Energy Australia Yallourn Draft Mine Rehabilitation Plan (DMRP)

By Friends of Latrobe Water

21 August 2025

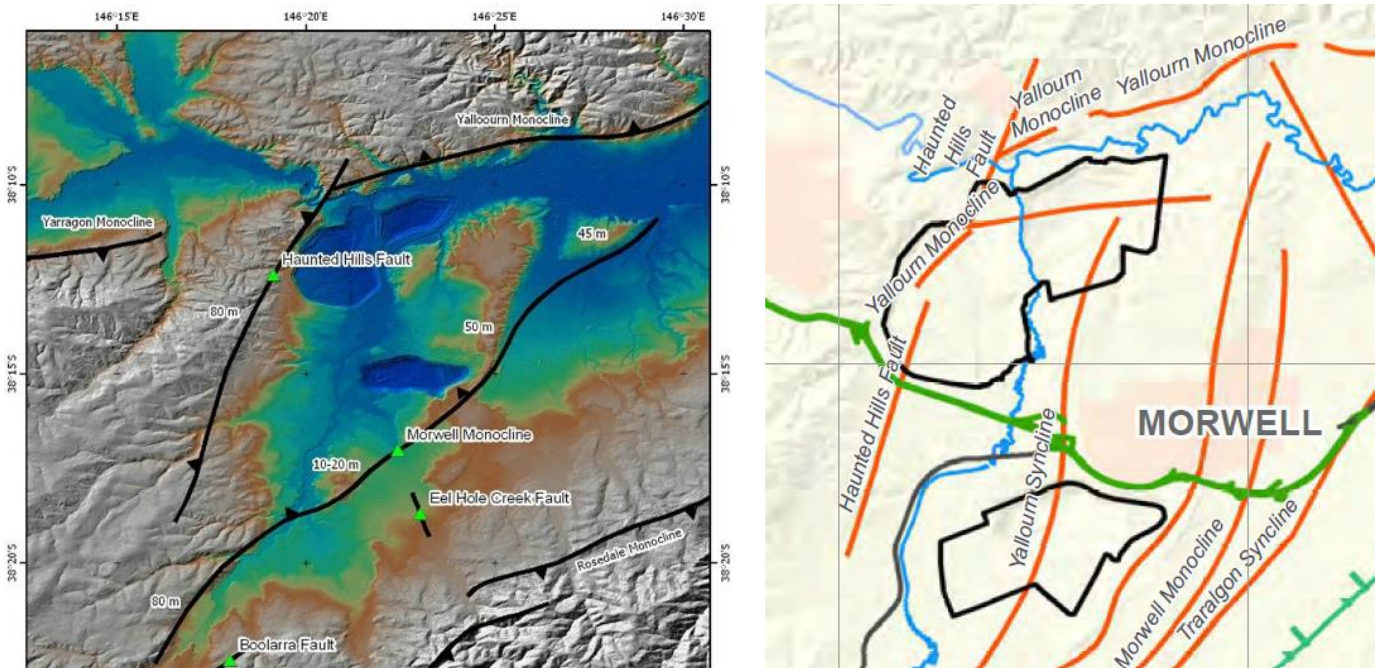
The Thomson reservoir case is relevant for Yallourn as it is located 35 km north of the mine and the fault understood to be associated with the main event (magnitude 5.0) in 1996 is the Yallourn Monoclinial Fault which runs close to Yallourn.

The Thomson Reservoir is located on the hanging wall of the Yallourn Monoclinial Fault, whilst Yallourn is located on the footwall.

The location of the reservoir with respect to the fault is important. A reservoir existing on the footwall of a reverse or normal fault, or over one block of a strike-slip fault would generally have a stabilizing effect, while a reservoir existing on the hanging wall of a reverse or normal fault, or directly over a vertical strike-slip fault, would have a destabilizing effect.¹⁵
